RANCHO SANTIAGO COMMUNITY COLLEGE DISTRICT

ADDENDUM NO. 1

Bid #1413 BR Signage and Wayfinding
at
Santiago Canyon College

January 18, 2022

**SIGN
DETAILS**

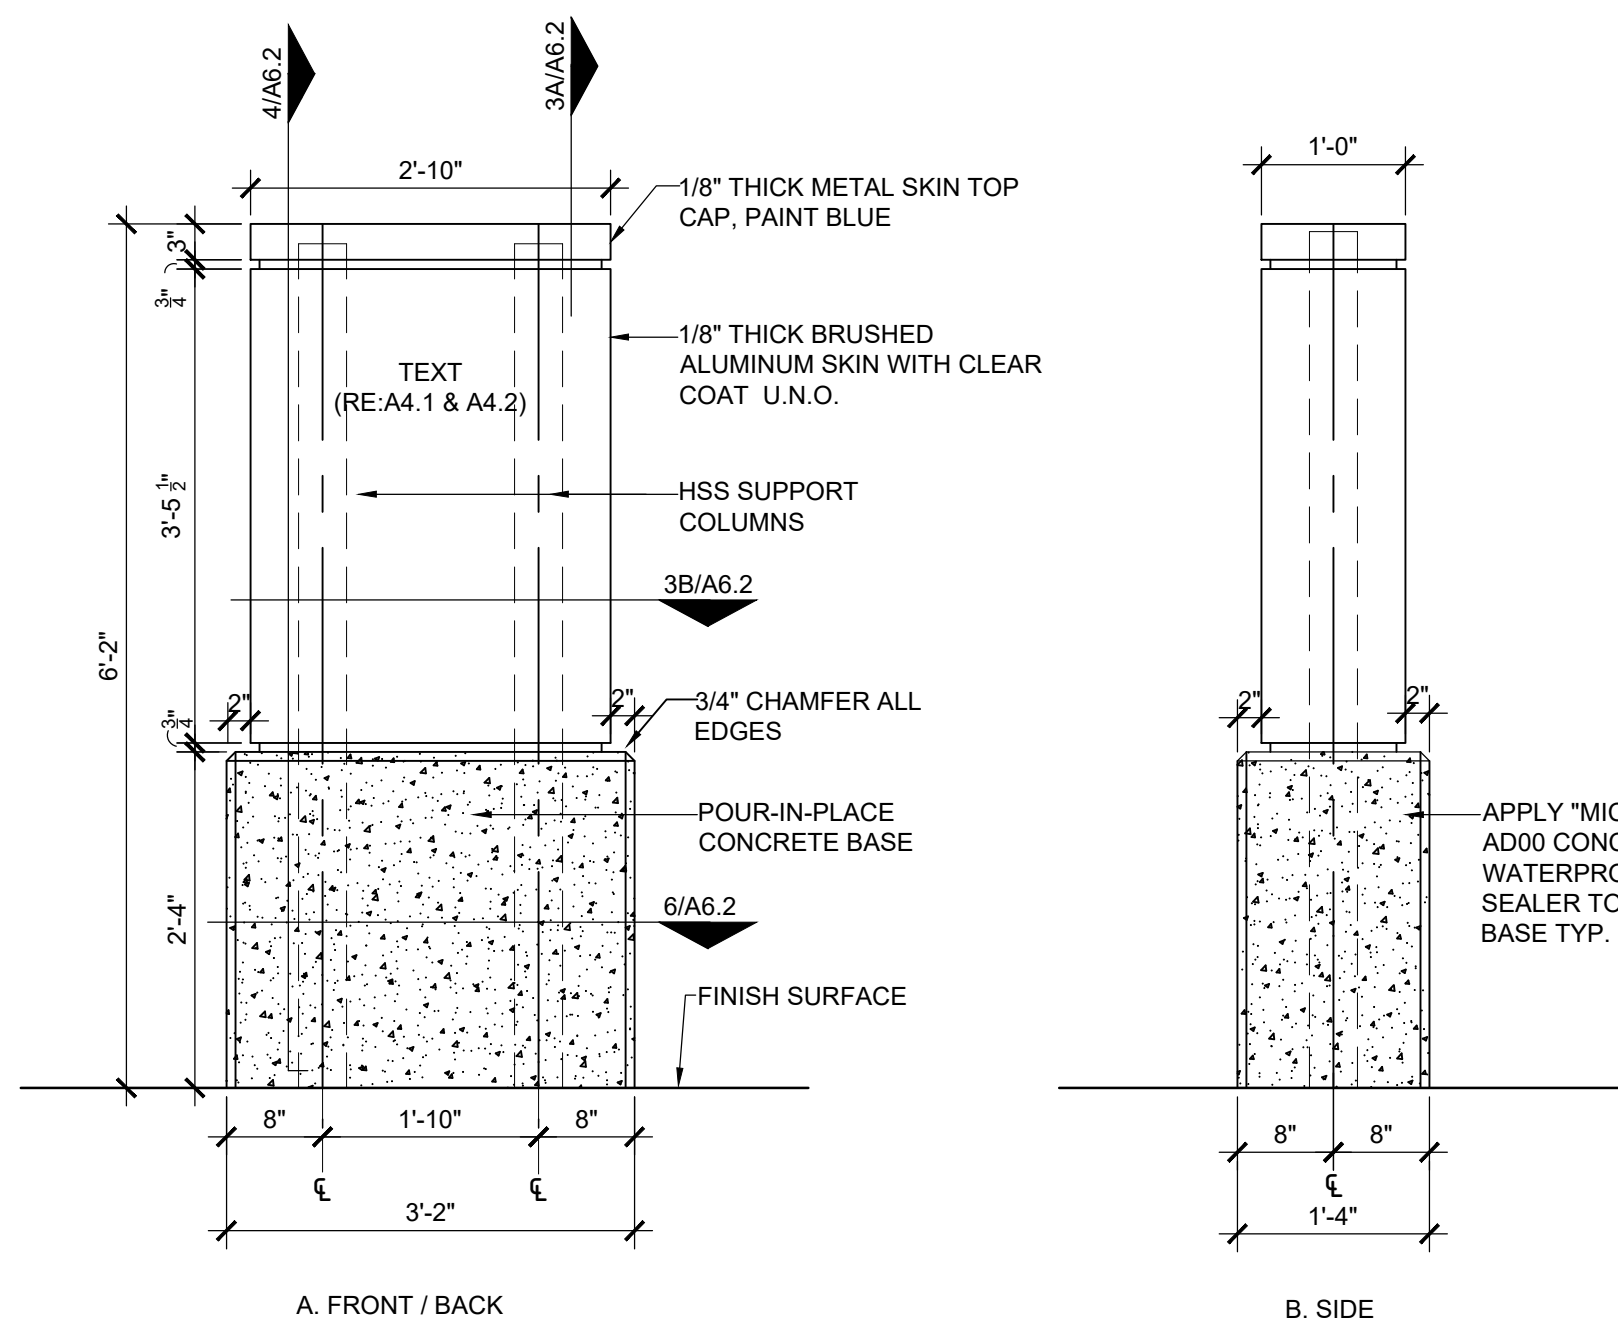
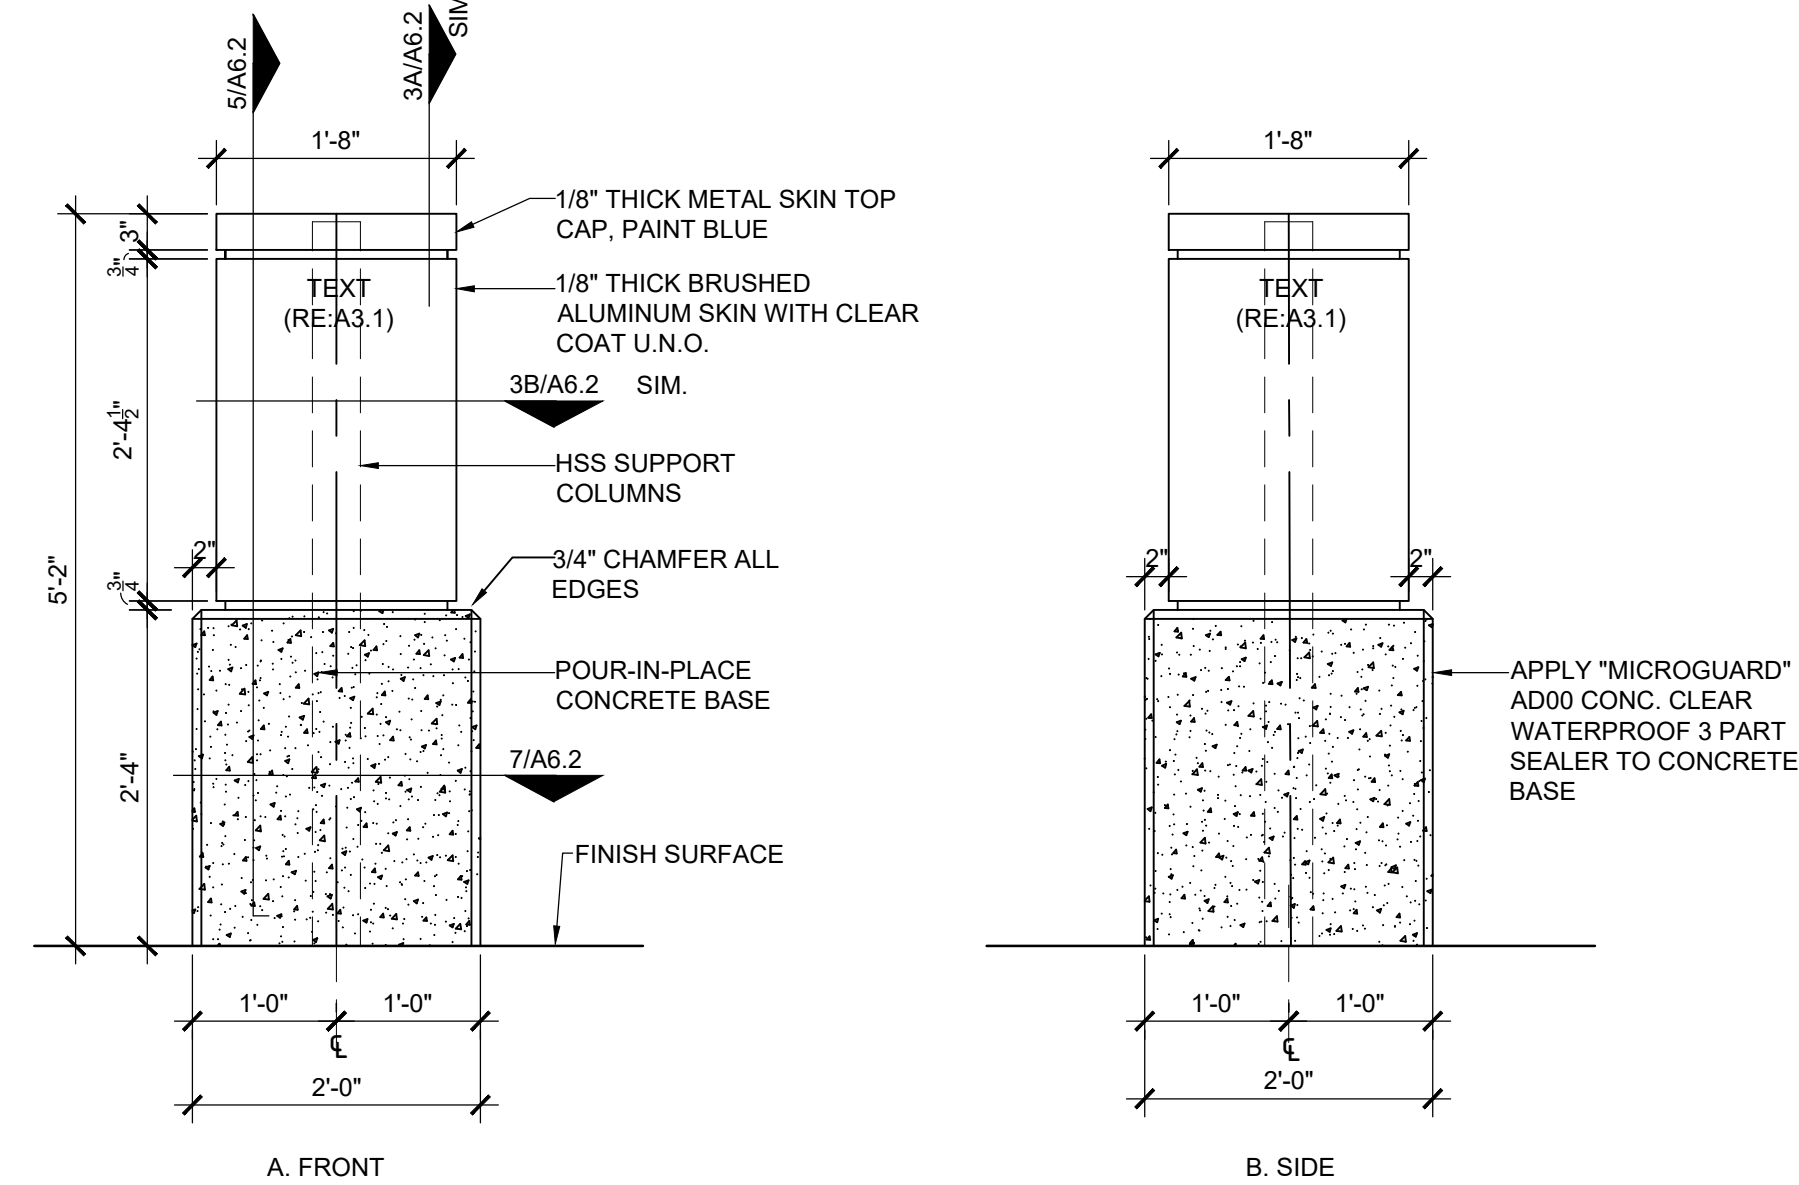
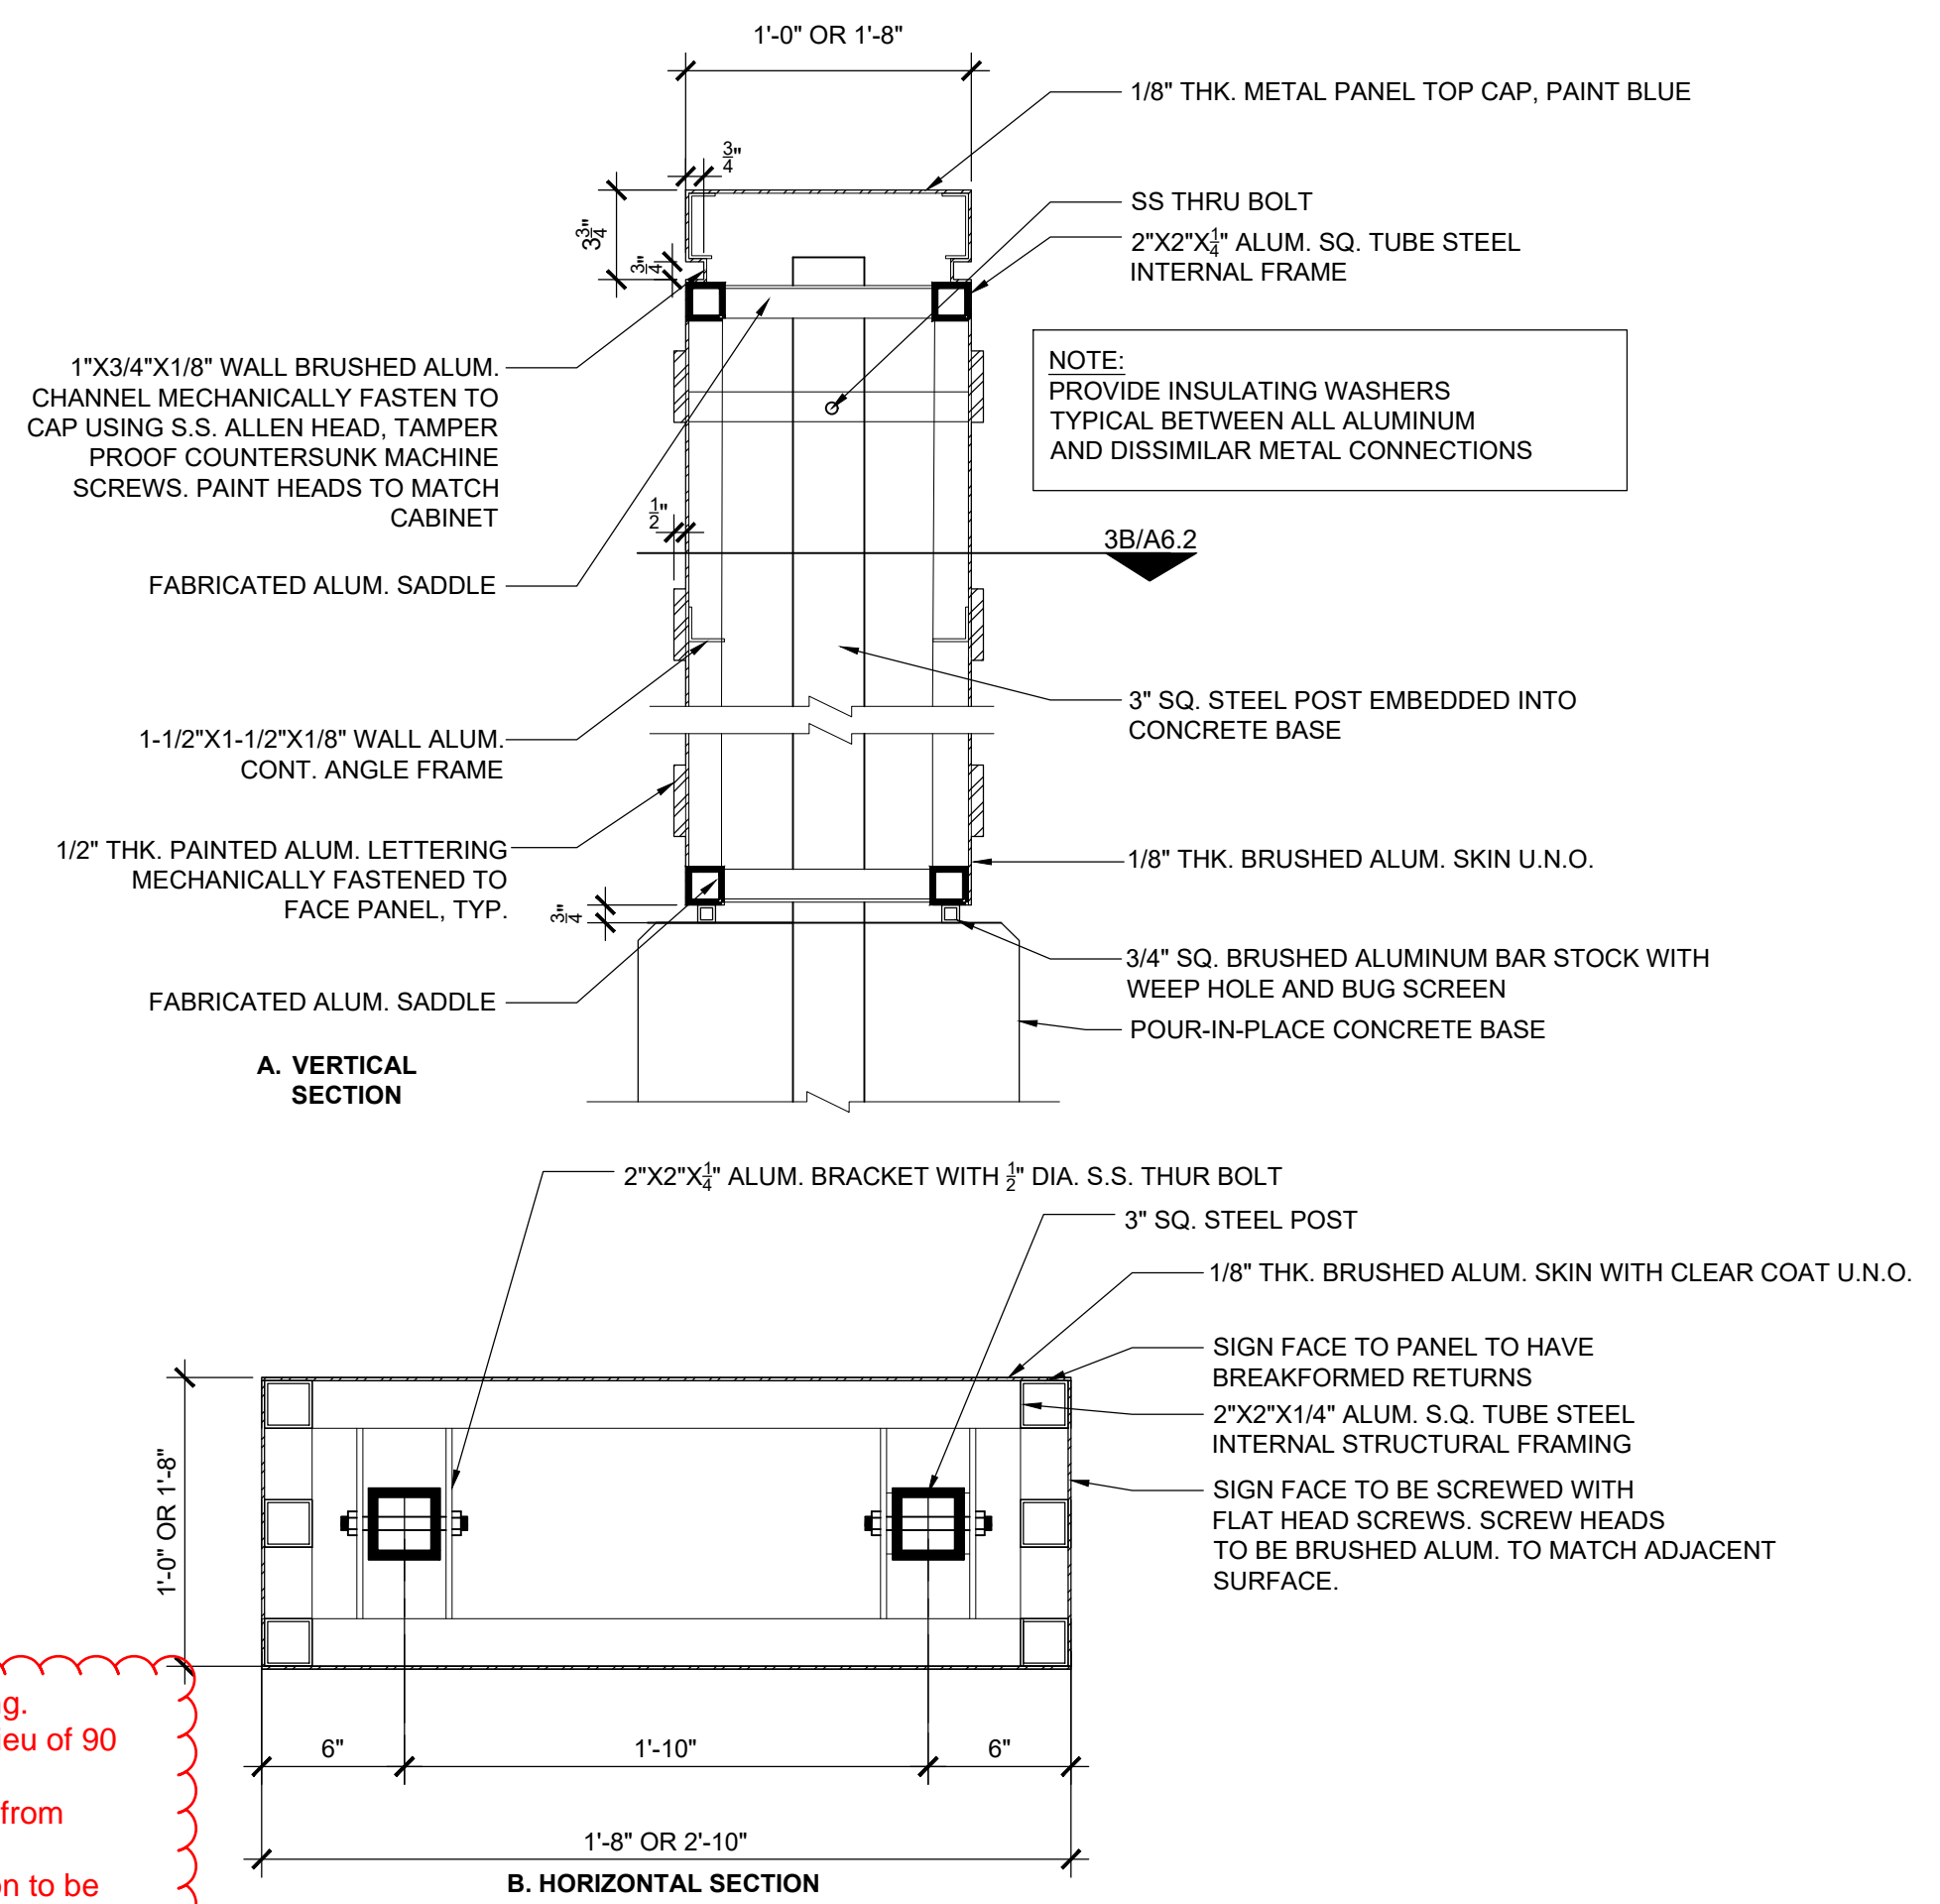
Refer to attached Drawings A6.2, Sign Details, General Notes. Revise General Note No. 1 as follows:

1. Contractor to repair existing hardscape, landscaping and irrigation at new construction, field verify.
 - A. PVC pipe and fittings to match existing.
 - B. Reroute with 45-degree elbows in lieu of 90-degree elbows.
 - C. Adjust adjacent existing sprinkler head positioning where spray is not spraying monuments.
 - D. Sprinkler heads to match existing and approved by District representative.
